Pentium® Processor Specification Update

Release Date: April 1998

Order Number 242480-036

2. **Incorrect TCP Pinout Drawing**

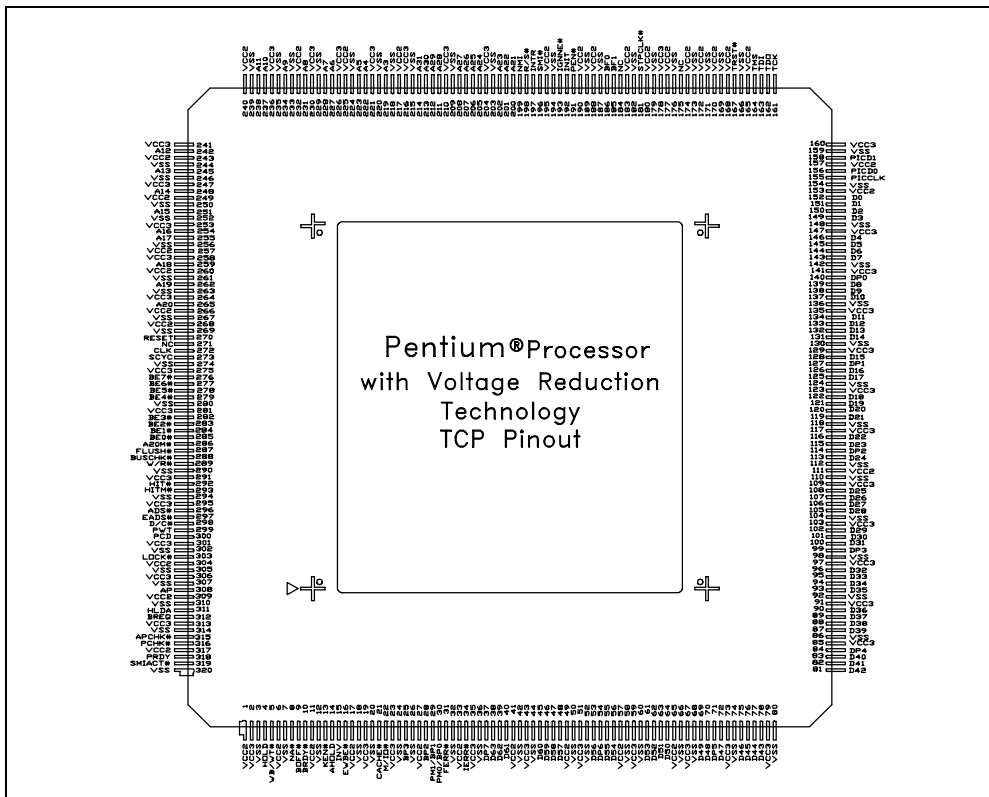
The TCP pinout drawing on page 8 of the *Pentium Processor with Voltage Reduction Technology* datasheet was inadvertently rotated. The correct orientation is shown below.

Figure14-1. Maximum Undershoot Level, Undershoot Threshold Level, and Undershoot Threshold Duration

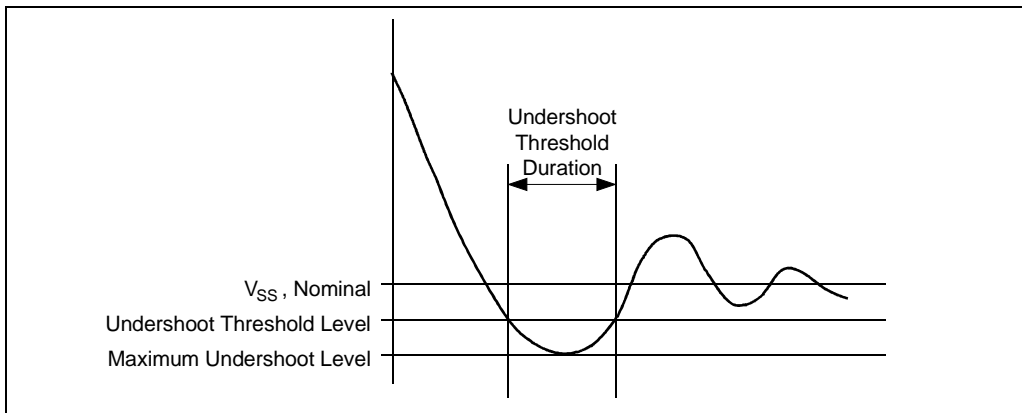
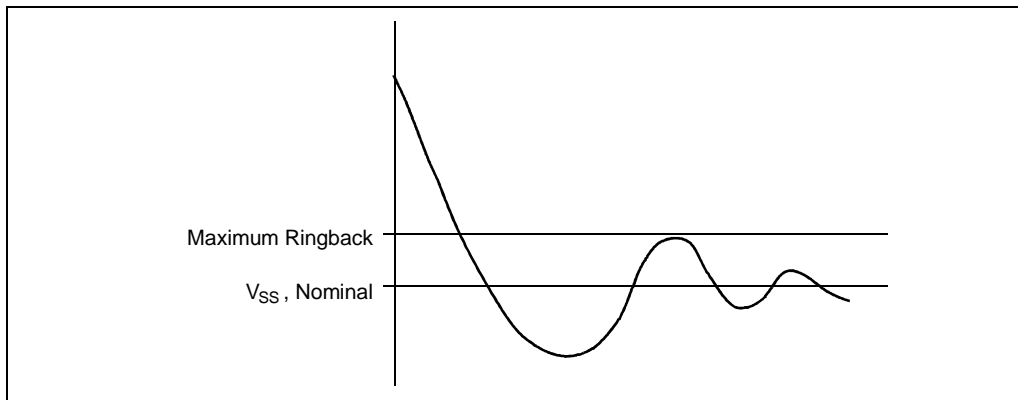
MAXIMUM RINGBACK SPECIFICATION: The maximum ringback of CLK associated with its low state (undershoot) must not exceed 0.8V as shown in Figure 14-1.

MAXIMUM UNDERSHOOT AND MAXIMUM RINGBACK SPECIFICATIONS: The display should show continuous sampling (e.g., infinite persistence) of the waveform at 500 mV/div and 5 ns/div (for CLK) for a recommended duration of approximately five seconds. Adjust the vertical position to measure the maximum undershoot and associated ringback. There is no allowance for crossing the maximum undershoot or maximum ringback specifications.

UNDERSHOOT THRESHOLD DURATION SPECIFICATION: A snapshot of the clock signal should be taken at 500 mV/div and 500 pS/div (for CLK). Adjust the vertical position and horizontal offset position to view the threshold duration. The undershoot threshold duration is defined as the sum of all time during which the clock signal is below -0.5V within a single clock period. The undershoot threshold duration must not exceed 20% of the period.

This undershoot specifications are illustrated graphically in Figure 14-1 and Figure 14-2.
